RAIB Report: Freight train derailment near Gloucester

I write to report¹ on the consideration given and action taken in respect of the 7 recommendations addressed to ORR in the above report, published on 9 October 2014.

Track Geometry Analysis at 5 May 2015

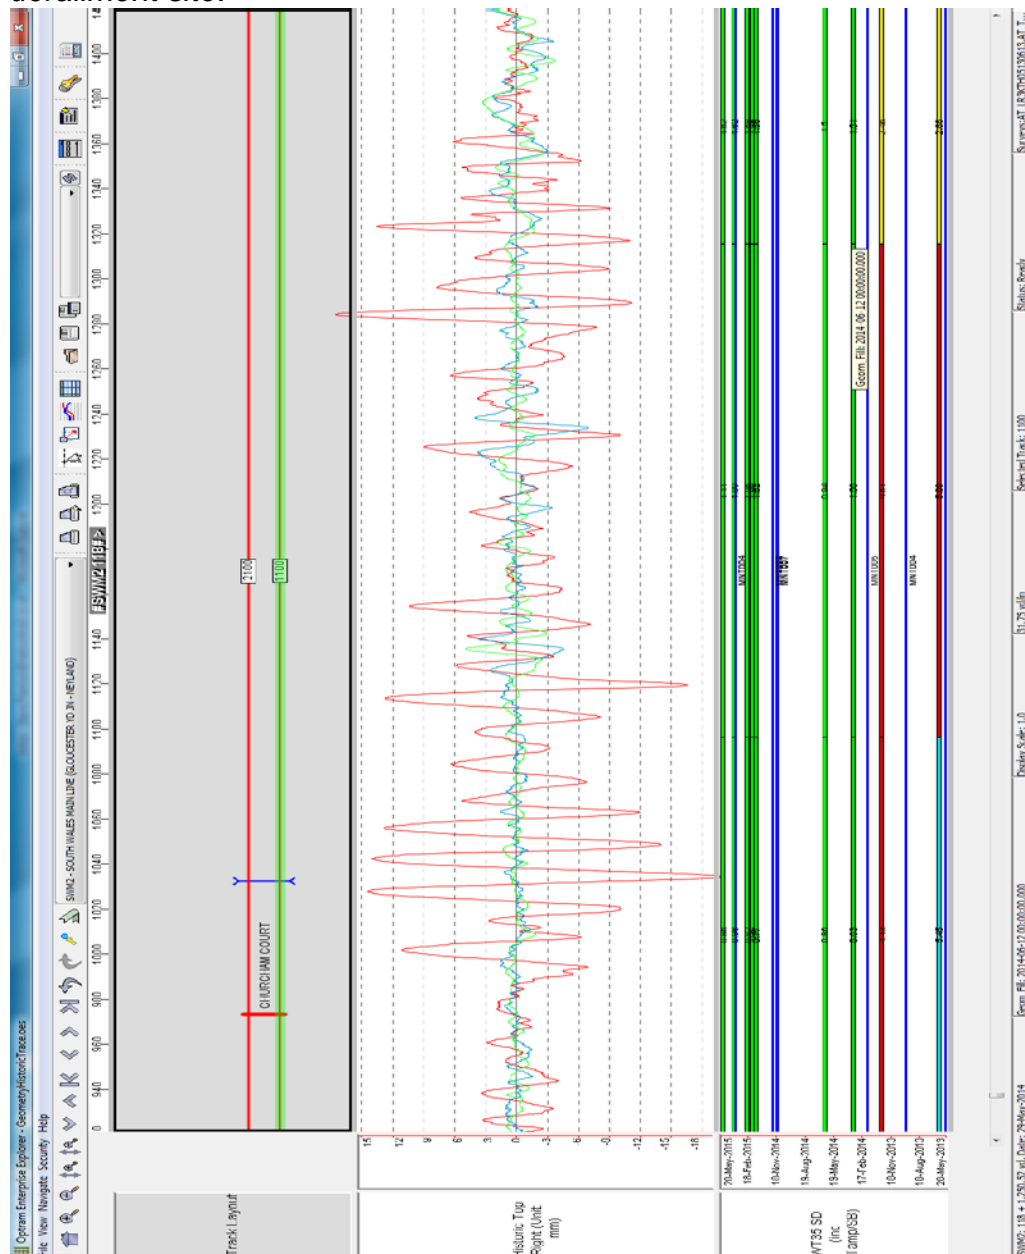
The middle section of the image shows the top trace, indicating vertical alignment. Right rail top has been used for simplicity although there was no discernible difference between both rails. The red trace is the top recorded on 13/6/13 before the derailment. Significant top faults are clearly evident on the approach to the point of derailment. The blue trace was recorded on 13/3/14 following track renewal and cess lowering to improve drainage, throughout the

length of the track shown in this image. The green trace was recorded on 1/5/15 and shows minimal change to the blue trace, indicating the sustainability of track quality.

The third section of the image shows successive track quality (WT35m) recordings since the derailment with the most recent at the top of the section. This shows the site was 'super red' at the time of the derailment (shown as light blue colour). Since renewal, this has remained in the 'good' band (shown as green). SDs have remained steady, well within the 'good band' limit of 2.2. This has been achieved without any significant interventions.

No alert or intervention limit track faults have been recorded.

The track asset is now in a good, sustainable position in the vicinity of the derailment site.

3. ORR is content that Network Rail has taken appropriate action to improve the drainage in the area of the derailment and has demonstrably improved track condition as a result.
